PERMIT NO. **20092820-A & 20091821-A**

BERRYBANK WIND FARM
PRE-DEVELOPMENT NOISE ASSESSMENT

Rp 002 R02 20180495 | 8 April 2019

Project: **Berrybank Wind Farm**
Pre-construction noise assessment

Figure 1: Vestas V136-4.2MW sound power level versus hub height wind speed, dB L_{WA}

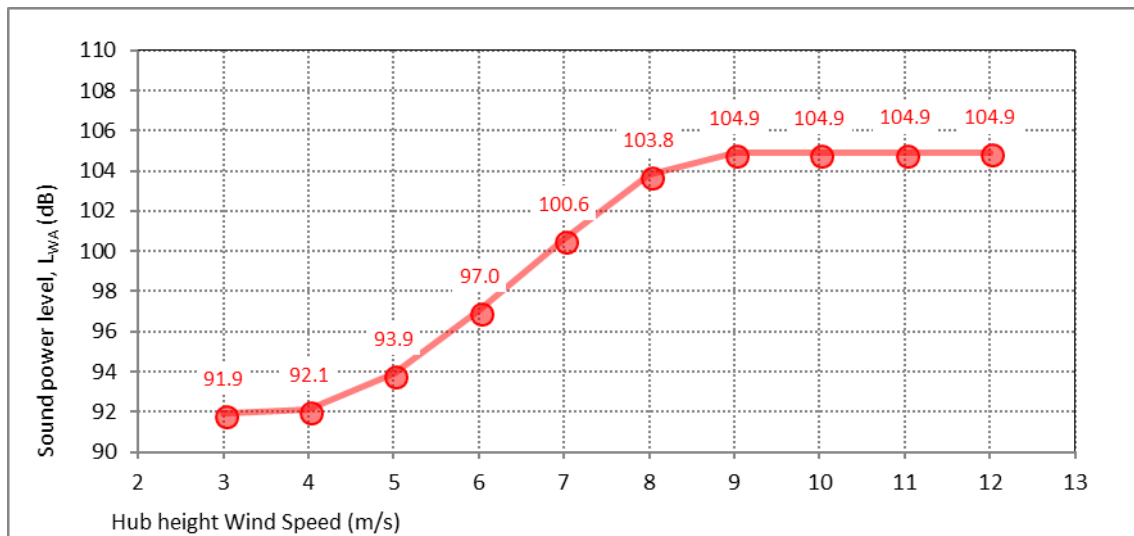
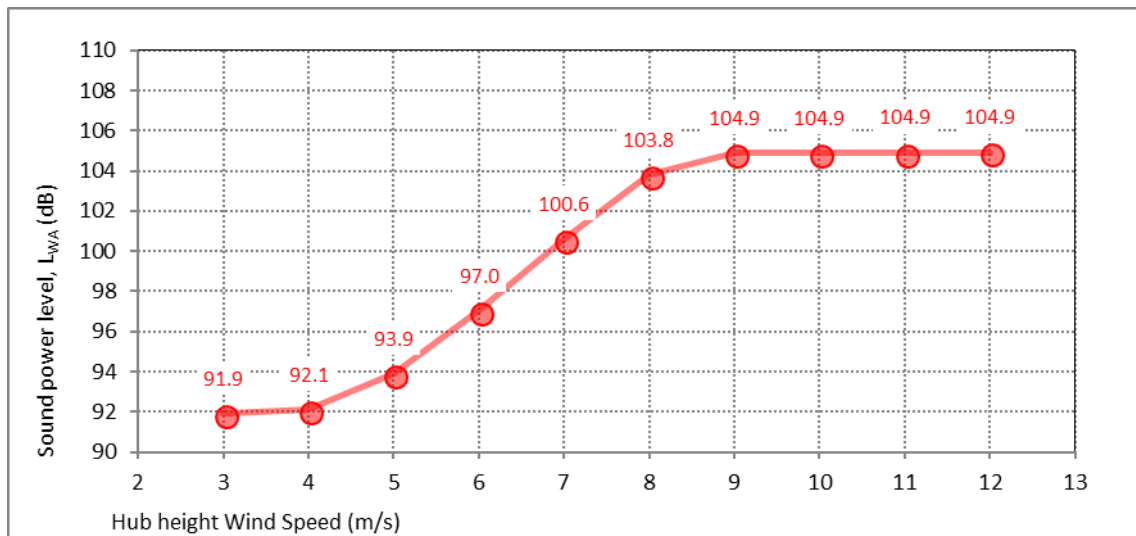
- The locations used by MDA for noise modelling are consistent with the locations shown in the MDA report.
- Sound power levels have been adjusted by 1 dB to account for uncertainty. Data provided by Vestas appears to be measured data under IEC 61400-11 ed.3. The IOA Good Practice Guide suggests that where data is based on measured data under IEC 61400-11 ed.3, the test uncertainty should be added to the source level. In the absence of test uncertainty, a factor of +2 dB should be added.

- We note that no non-associated receivers are above 39 dB(A). Therefore, we believe that the above items would not result in a change in the conclusions of the preconstruction noise assessment.
